Product Advisory

Issue Date: 03-June-2021

Addition of dry film solder resist in substrate manufacturing

Images below from another device is an example of the cosmetic difference:

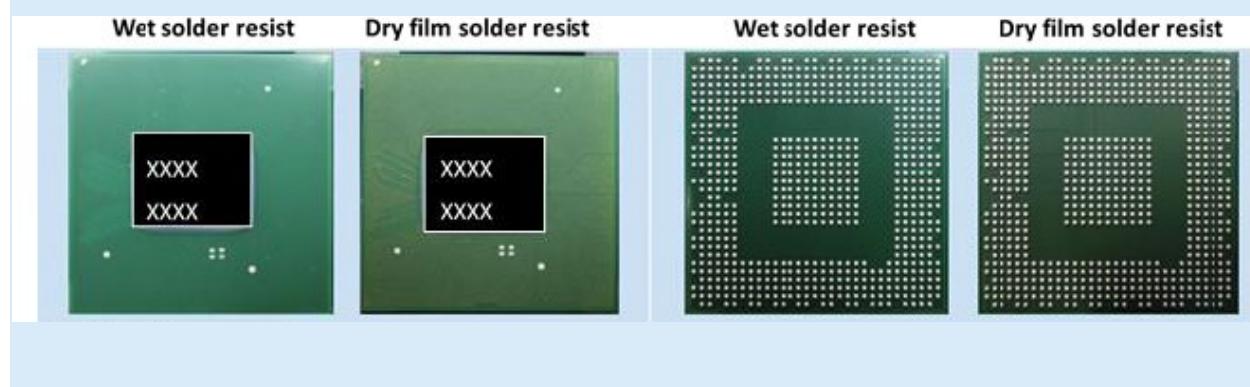
Addition of dry film solder resist to current wet solder resist process. Dry solder resist film is translucent, and is currently used in production on other Broadcom high volume products. Dry solder resist film is Form, Fit and Function identical to the wet solder resist currently used, except for the cosmetic difference. Use of the dry solder resist film has no impact to customers SMT process.
